DELEGATED REPORT

Application Reference/s:	PL/2023/11194 & PL/2024/08122
Application Type:	Full planning permission & listed building consent
Target decision dates:	22nd October 2024

Site Address:	Flat 5, 11 St Mary Street, Chippenham, Wilts, SN15 3JJ
Proposal:	Replace 3 rotten wooden windows with like-for-like wooden sash windows (One in kitchen, 2 in sitting room) with shutters to remain in situ (Retrospective)
Recommendations:	Grant conditional planning permission Grant conditional listed building consent

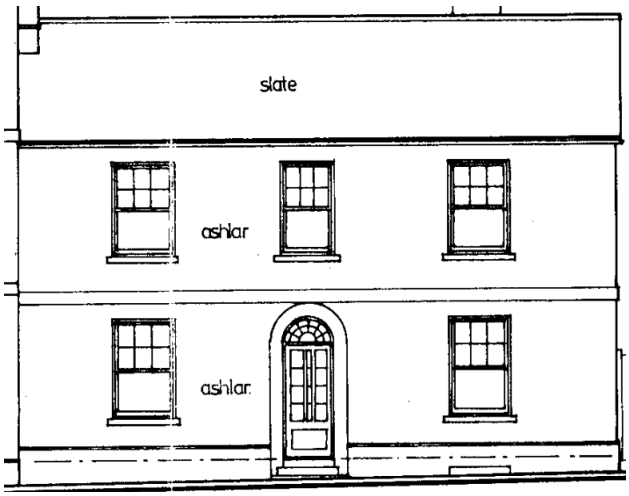
1.1. Retrospective Planning Permission and Listed Building Consent is sought for replacement of 3no. sash windows in the front of no.11 St Mary's Street, serving the first floor flat. The windows to be replaced are highlighted yellow int eh image below:

7.2.5 From this it is clear that the format of the sash windows was part of the heritage listing:

Format of windows in 2004

7.2.7 The applicant suggests that the previous windows were installed c. 2007. This is not substantiated in any way. The 2004 approval however provided for refurbishment of the windows and the adding applied glazing bars to the lower sash so as to 'match' the 6 panes of the upper sash. It thus seems far more likely that the windows recently removed were single-glazed sash windows that existed in 2004 but unfortunately the application is not supported by any detailed assessment of the removed windows. Records from an officer visit to the site in 2007 however indicate the windows then to have been in poor condition and having been subject to various interventions such that they were unlikely to have contributed to any great degree to the heritage significance of the building in terms of their fabric.

7.2.8 The replacement windows, whilst said to be like-for-like are not so, as they include double-glazed units as opposed to the single-glazed windows that likely preceded them. Historic England Advice Note 18 (HEAN 18) accepts the principle of slim-profile double glazing units albeit within the emphasis upon upgrading and refurbishing existing window frames rather than replacing them. Exceptions to the principle include windows which retain historic glass of interest, windows of historic or architectural interest whose frames / glazing bars cannot support slim-profile or vacuum double-glazing, and windows with leaded lights. These exceptions are judged not to apply in this instance.

7.2.9 Nevertheless, and as identified within the Conservation Officers commentary, in this case the proposed replacement windows are noted to have been carefully specified and are appropriate design, construction and detailing and represent suitable replacements for the previous windows. As such it is judged that the replacement windows do not harm the heritage significance of the building. In turn the windows do not impact upon the setting of neighbouring and opposite listed buildings or the character and appearance of the conservation area, with no harm caused to any significance of them as a heritage assets.
